APPLICATION FOR AMENDMENT TO PERMIT

Amendment No. 1
Portland, Maine, 5/7/90

RE: 257 Deering Avenue

Your application to enclose boiler and to improve loading access has been reviewed and a permit is herewith issued subject to the following requirements:

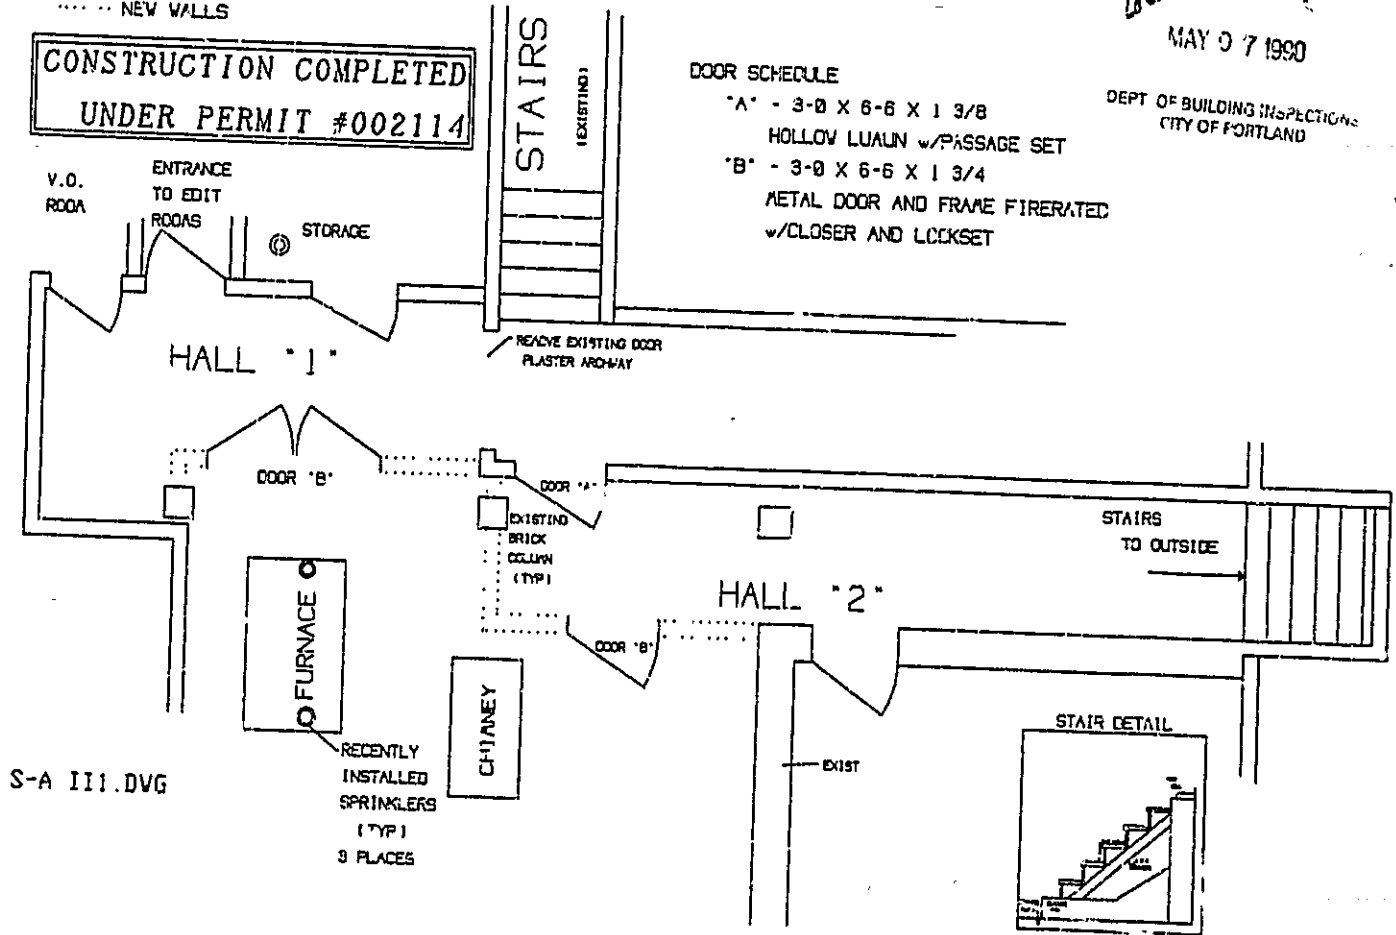
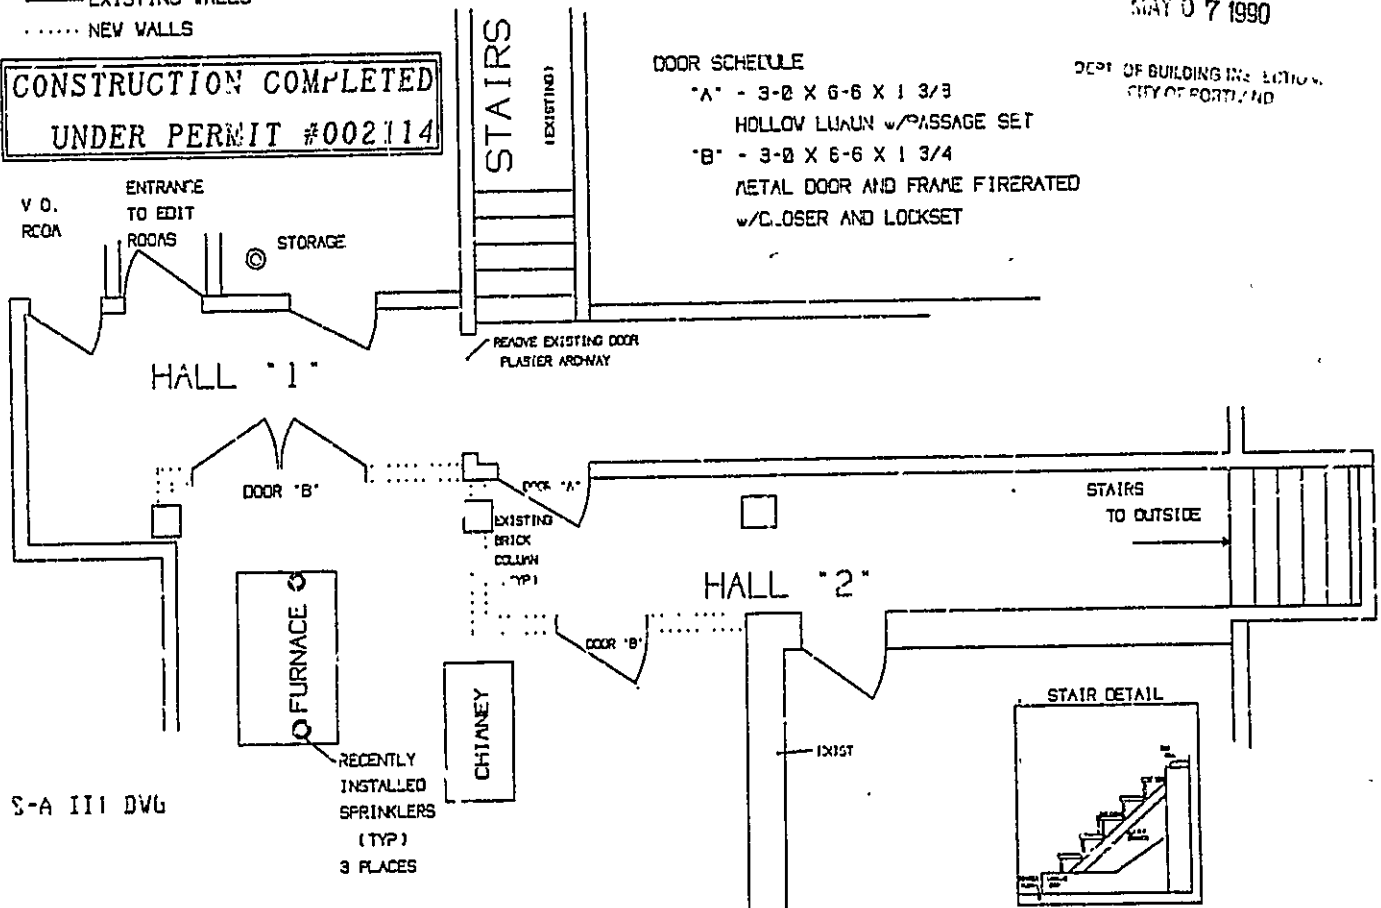
1. The boiler room must be enclosed with one hour rating partitions, with either two(2) residential sprinkler heads supplied from domestic water ^{on} a one hour rated ceiling.
2. Your stair detail shows a 7-1/2" riser with a 9-5/8" tread. On commercial buildings, a maximum of 7" rise with 11" minimum tread must be used.
3. Handrails shall be on both sides of stairs as per the building code.

Notice on the drawings that 3 sprinklers have been installed, two over the furnace and one in the storage room across Hall "1".

STAIR DETAIL

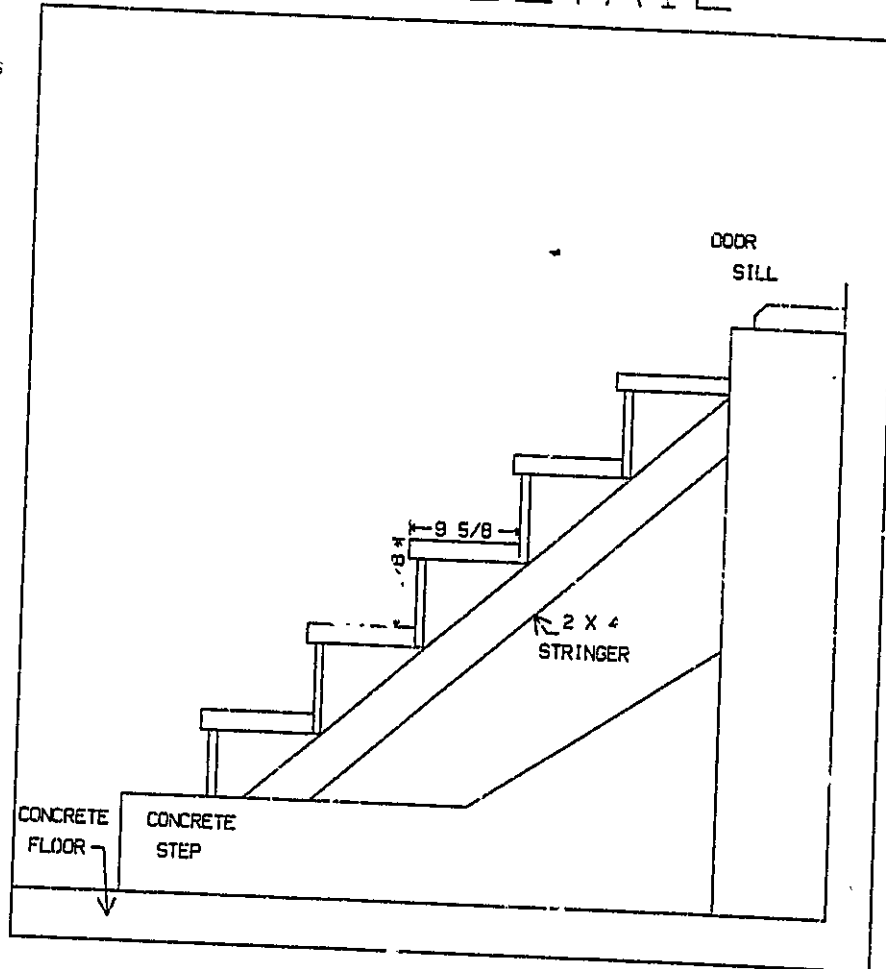
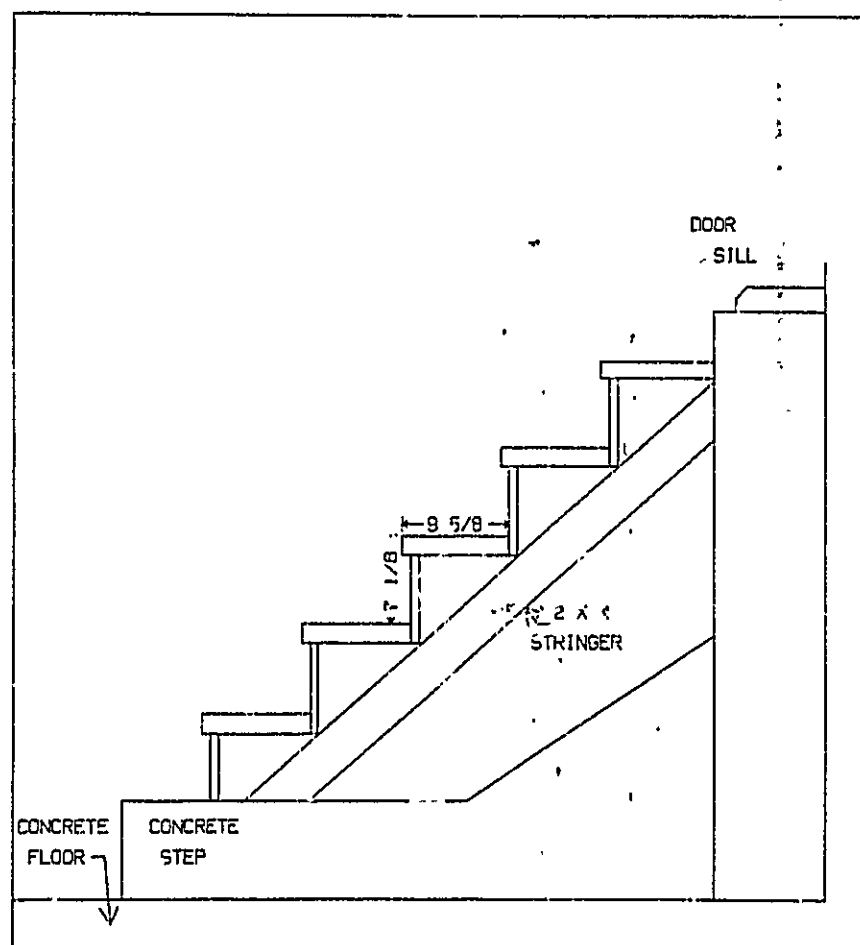
8 1/2 Rise 9 1/4 Tread
